APPLICATION NO.	FILING DATE	FIRST NAMED INVENTOR	ATTORNEY DOCKET NO.	CONFIRMATION NO.
10/750,400	12/31/2003	Joakim Gripemark	03370-P0068A	8989
24126	7590	02/14/2006	EXAMINER	
ST. ONGE STEWARD JOHNSTON & REENS, LLC 986 BEDFORD STREET STAMFORD, CT 06905-5619			SY, MARIANO ONG	
			ART UNIT	PAPER NUMBER
			3683	
DATE MAILED: 02/14/2006

DETAILED ACTION

Replacement Sheet
Appn. No. 10/750,400
Disc Brake
Joakim Gripemark, et al.
SSJR File 03370-P0068A

Fig. 3

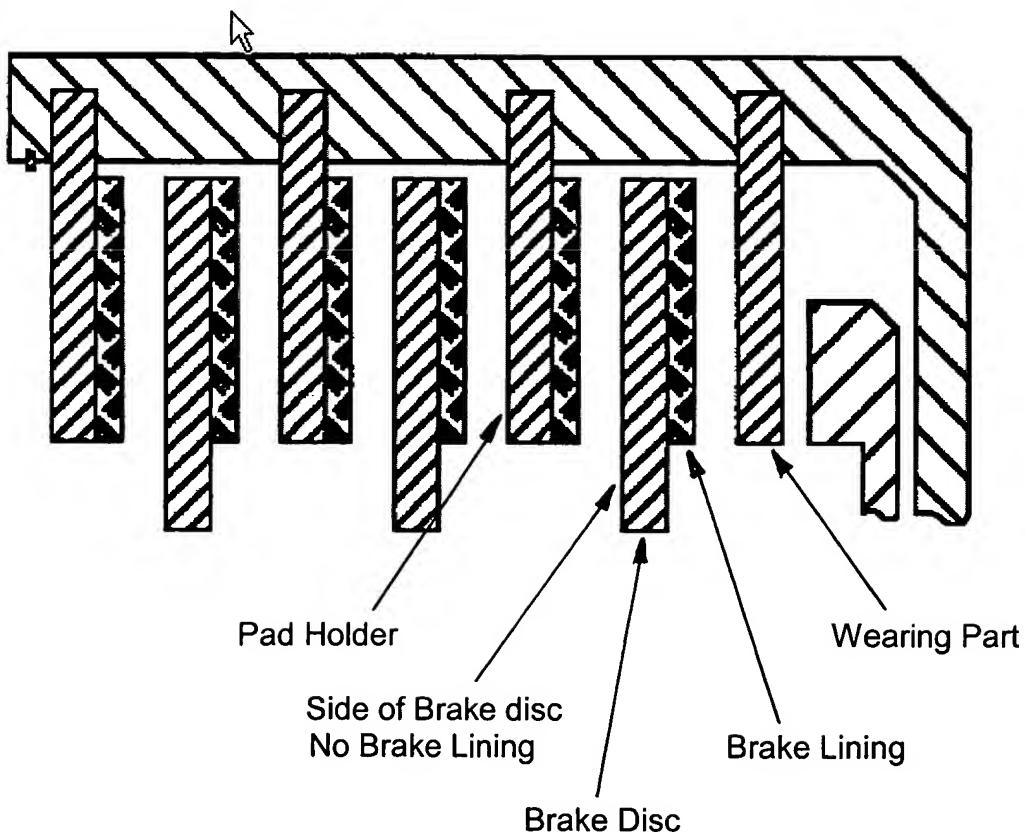
Note the clutch, which is functionally equivalent to a disc brake, having a caliper (see fig. 3 and 4) with a disc having a brake lining material on one side and that there is no brake lining material on the other side of the disc, wherein wearing part (shown as the last part to the right end attached to the caliper) is placed in the caliper for contact with the brake lining material of the disc during braking, and pad holder (left hand

direction of the brake disc) is arranged on the side of the brake disc having no brake lining.

10. Examiner maintains Takakura et al. (US 5,975,267) still reads on amended independent claim 1 and new independent claim 11. See attached Fig. 3 below. The pad holder is arranged on the side of the brake disc having no brake lining.
